SUBDIVISION AUTHORITY AGENDA MEETING NO. 24

File No. LDA25-0171

RE: Tentative plan of subdivision to create 16 industrial lots from a portion of Lot 1, Block 1, Plan 152 0434 located north of 118A Avenue NW and east of Winterburn Road NW; **WINTERBURN INDUSTRIAL AREA EAST**

SUBDIVISION CONDITIONS OF APPROVAL MAP

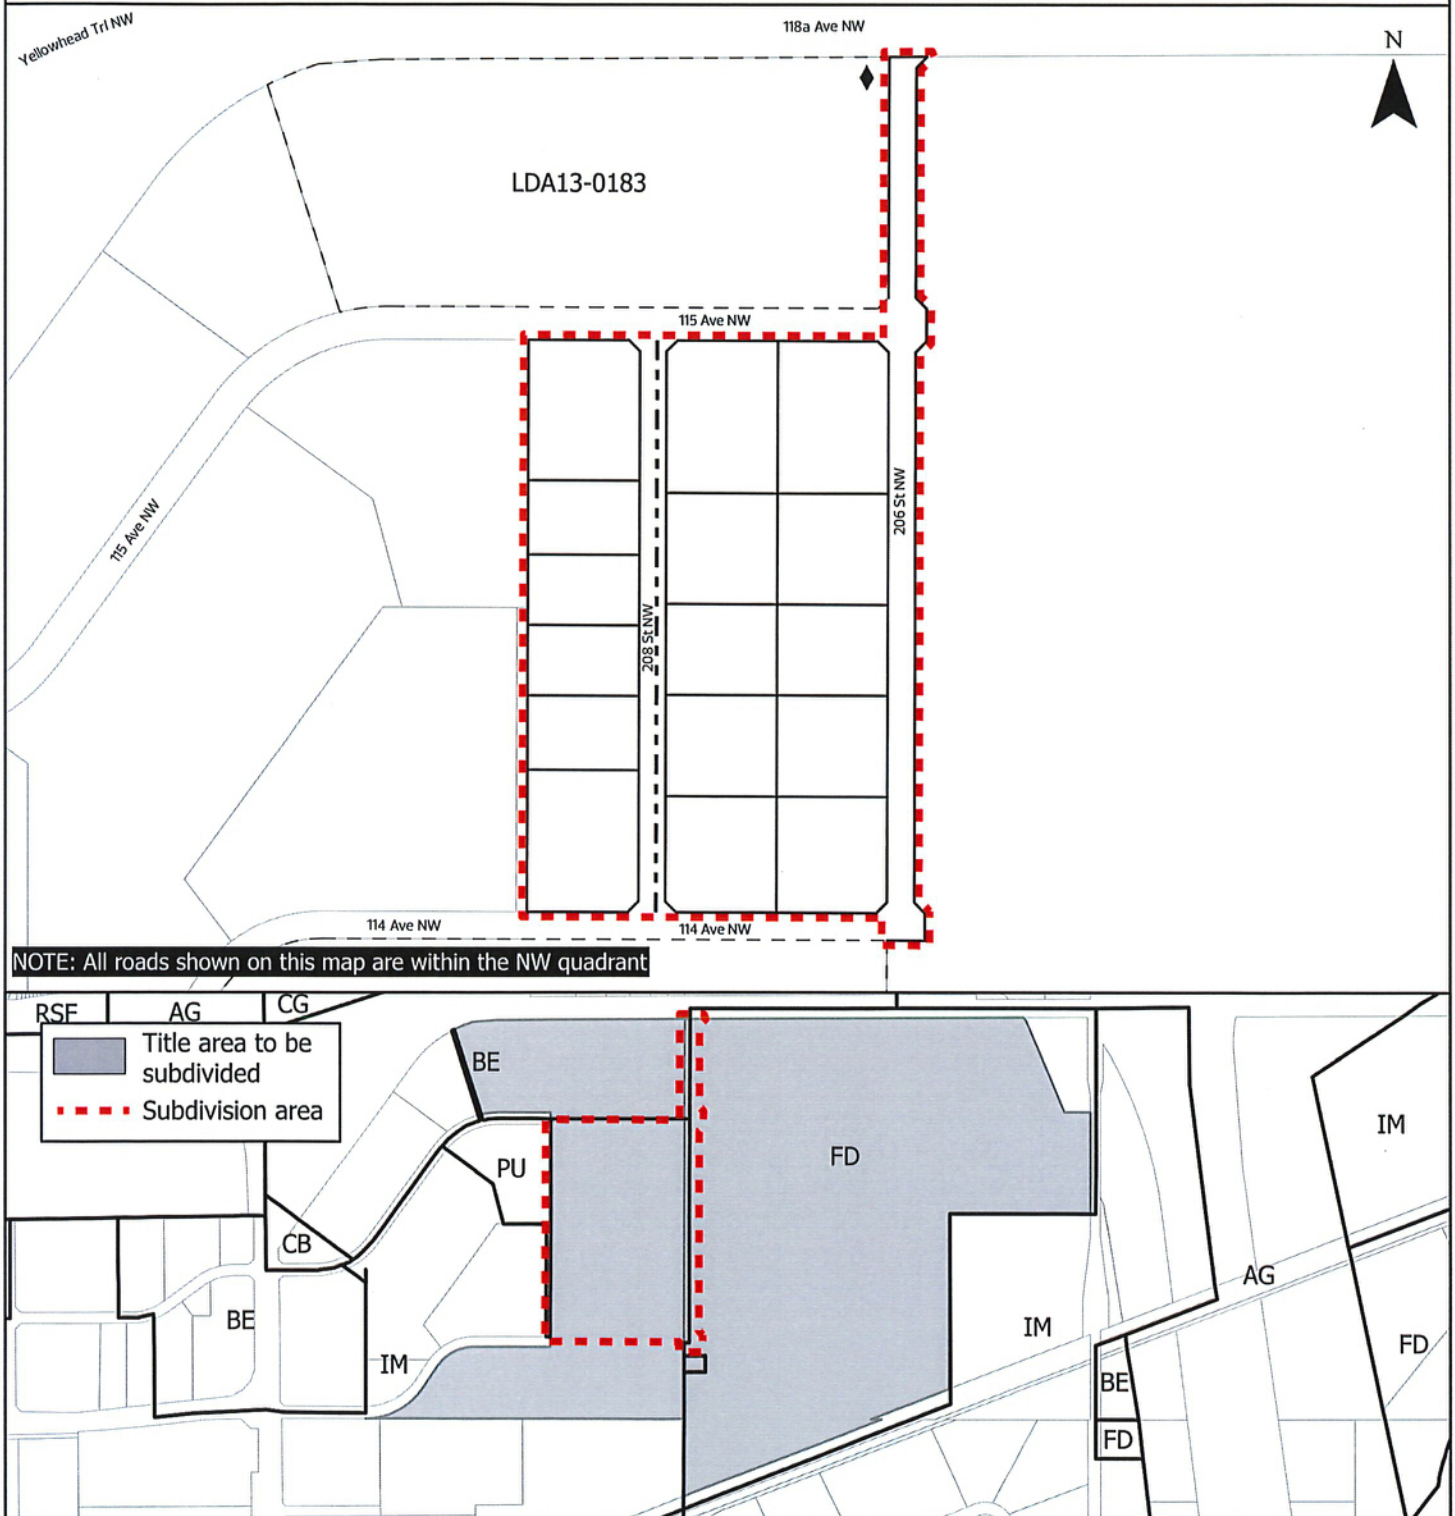
3. that the owner dedicate a 6 m x 6 m corner cut in accordance with the Complete Streets Design and Construction Standards and to the satisfaction of Subdivision and Development Coordination, as shown on the "Conditions of Approval" map, Enclosure I;

6. that the owner construct 208 Street NW to a local industrial roadway standard, including a sidewalk on one side, to the satisfaction of Subdivision and Development Coordination, as shown on the "Conditions of Approval" map, Enclosure I.

TENTATIVE PLAN

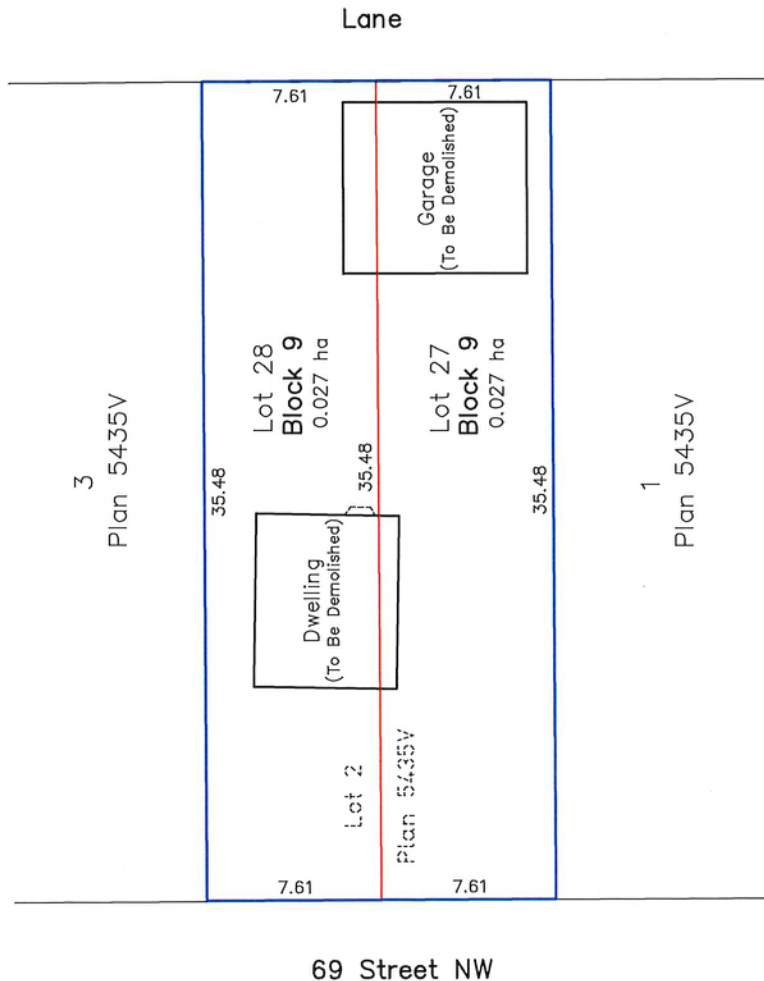
1. that the owner make satisfactory arrangements with EPCOR Water Services Inc. and EPCOR Drainage Services for the provision of separate services (water and sewer) to the proposed north lot;
2. that the owner apply for a permit to demolish the existing dwelling and garage prior to endorsement of the final plan. Demolition permits can be obtained from Development Services. Apply online at www.edmonton.ca/permits; and
3. that the owner pay all outstanding property taxes prior to the endorsement of the plan of survey.

- Access for future development must be to the adjacent alley as per the General Regulations (Section 6.1) in the 2.10 RS - Small Scale Residential Zone of Zoning Bylaw 20001.

- The existing bollards that encroach onto the alley right-of-way must be removed. Permanent objects are not permitted to encroach within road/alley right-of-way without entering into an Encroachment Agreement with the City of Edmonton. Email encroachmentagreements@edmonton.ca for information.

- The existing services (water and sanitary) enter the proposed subdivision approximately 4.59 m north of the south property line of Lot 2 off the lane. As per the EPCOR Drainage Services Bylaw and the EPCOR Water Services and Wastewater Treatment Bylaw, these services cannot cross the proposed property line.

- If power service crosses the proposed property line the owner may be required to provide a blanket easement in favour of EPCOR Distribution & Transmission Inc. If required, said easement shall be registered prior to or concurrent with the final plan of survey (contact EPCOR Land Administration Group at 780-412-3252).

TENTATIVE PLAN

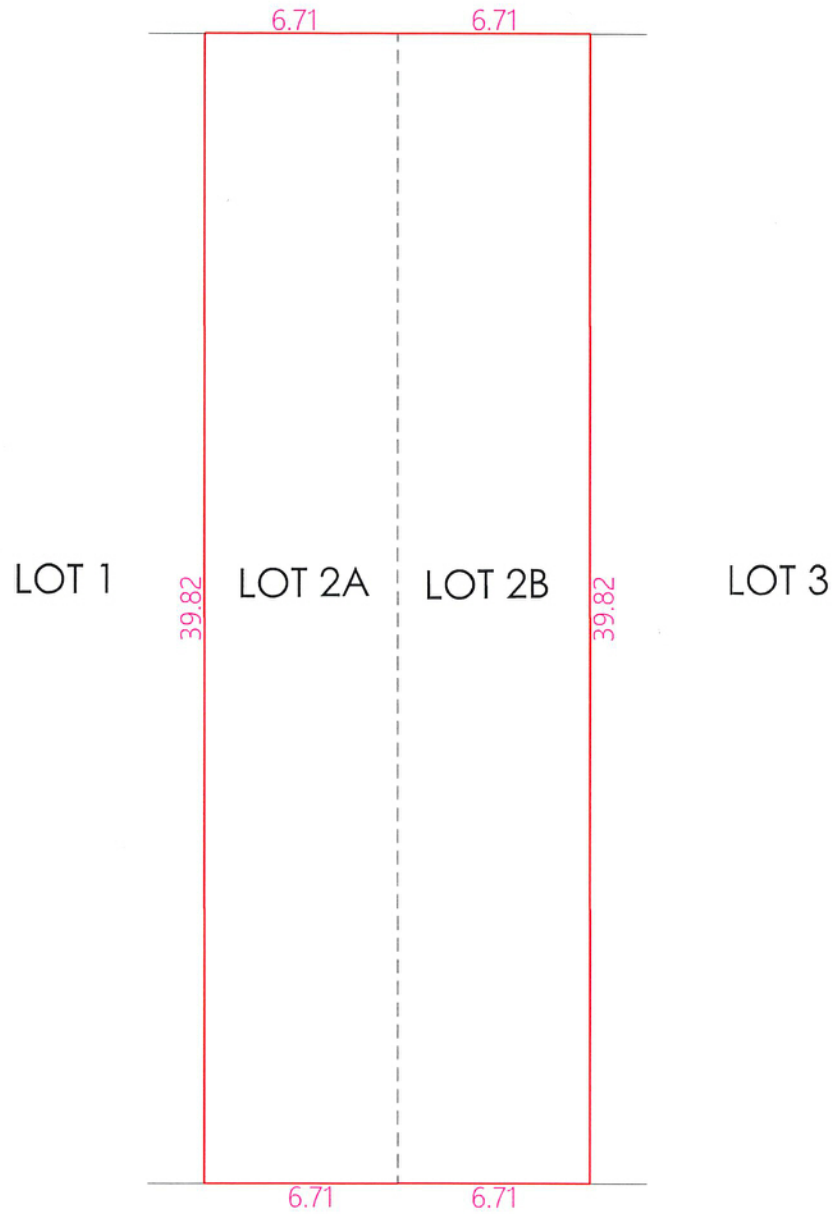
1. that the owner make satisfactory arrangements with EPCOR Water Services Inc. and EPCOR Drainage Services for the provision of separate services (water and sewer) to the proposed east lot; and
2. that the owner pay all outstanding property taxes prior to the endorsement of the plan of survey.

- The existing garbage enclosure that encroaches onto the alley right-of-way must be removed. Permanent objects are not permitted to encroach within road/alley right-of-way without entering into an Encroachment Agreement with the City of Edmonton. Email encroachmentagreements@edmonton.ca for information.

- The existing services (water and sanitary) enter the proposed subdivision approximately 6.08 m east of the west property line of Lot 2 off the lane. As per the EPCOR Drainage Services Bylaw and the EPCOR Water Services and Wastewater Treatment Bylaw, these services cannot cross the proposed property line.

- There is a deficiency in on-street hydrant spacing adjacent to the property. The applicant/owner is advised to review on-site fire protection requirements to ensure adequate coverage (contact EPCOR Water at 780-412-3955).

- There is an existing power pole that may interfere with access to the proposed Lot 2A. Subdivision Planning recommends that the applicant/owner contact EPCOR Distribution & Transmission to confirm whether this pole will inhibit alley access to the site, which may result in

- Overhead power lines are located on or adjacent to the subject site. It is important to prevent structural conflicts with electrical equipment. At the Development Permit stage, power poles, transformers, and other electrical equipment near the subject site must be included on all site plans and drawings. If a structure is greater than 5.5 m in height and has a setback of 4.5 m or less from the property line, please advise EPCOR Power's Customer Engineering Services (CES@epcor.com or 780-412-3128). They will provide feedback from a safety perspective, to help ensure Alberta Electrical Utility Code clearance requirements are achieved. For more information, refer to EPCOR Power's website at www.epcor.com (search "Building Structures and Power Equipment Clearances").
